Chemsol, Inc. Superfund Site

Appendix - A

Transcript of the August 27, 1997 Public Meeting

3 - - - - - x
4 PUBLIC MEETING
5 FOR THE PROPOSED PLAN FOR FINAL CLEANUP
6 AT THE CHEMSOL, INC. SUPERFUND SITE IN :
7 PISCATAWAY, NEW JERSEY
8 - - - - - x

FIGURE 4-1

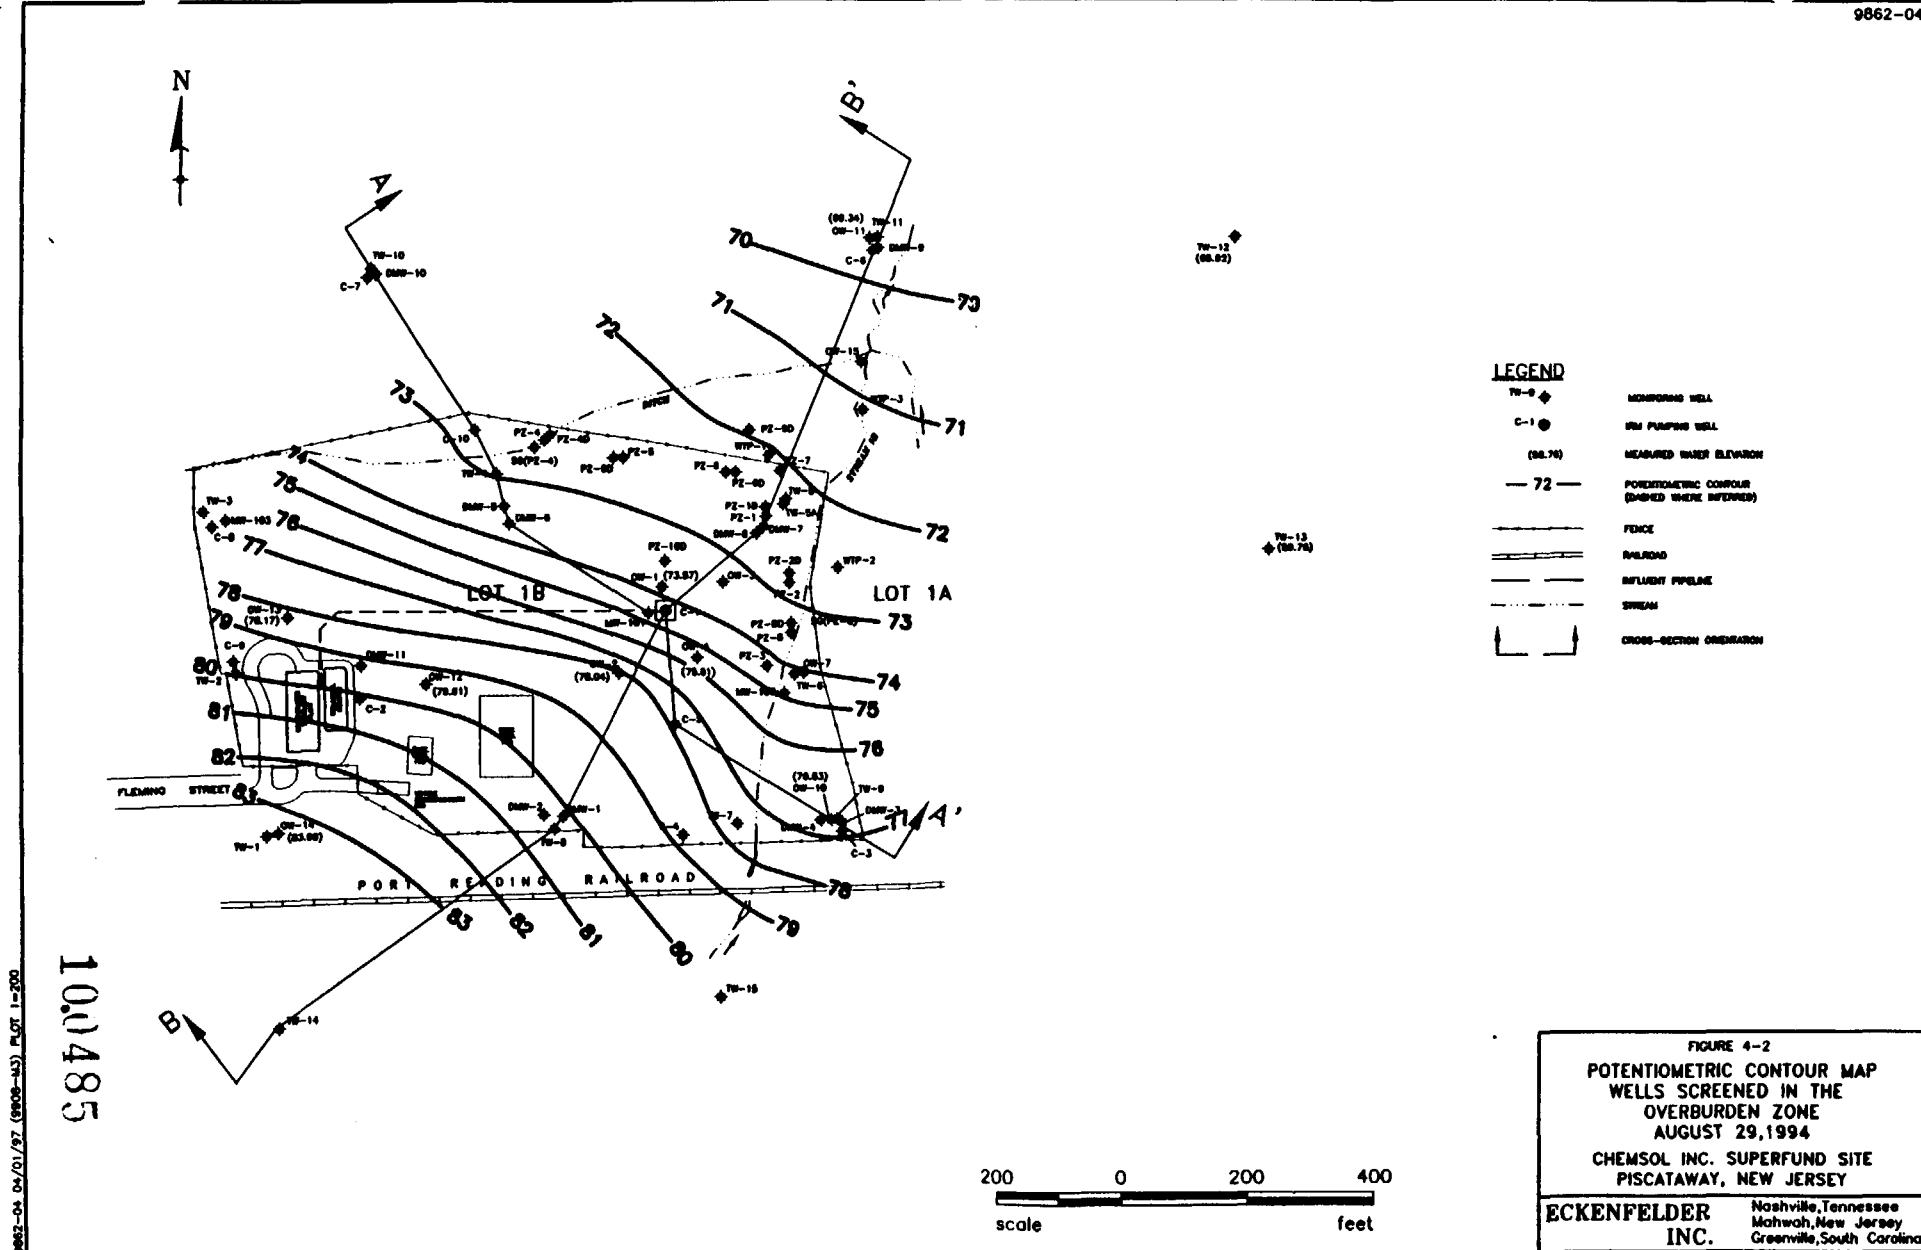
FS concludes the upper gray shale acts as a hydraulic barrier that would prohibit this flow. See Figure 3-2. This misinterpretation precludes the preliminary model's ability to accurately model flow in the Site's complicated geologic units. The geology of the Chemsol site is complicated because of the significantly complex hydrostratigraphic vertical relationships, such as the dipping of the bedrock units and the presence of hydraulic barriers with the associated effects on hydraulic head. Further, groundwater flow at the Site demonstrates a significant downward, vertical flow component due, in part, to the presence of hydraulic barriers. Because the FS model compares wells in disparate water-bearing zones (FS Figures 1-15 through 1-19), thus, not taking into account the complicated groundwater flow regime at the Site, it misinterprets the direction and magnitude of groundwater flow, which renders the model unable to depict site conditions, predict capture zones, or design an appropriate long-term monitoring program.
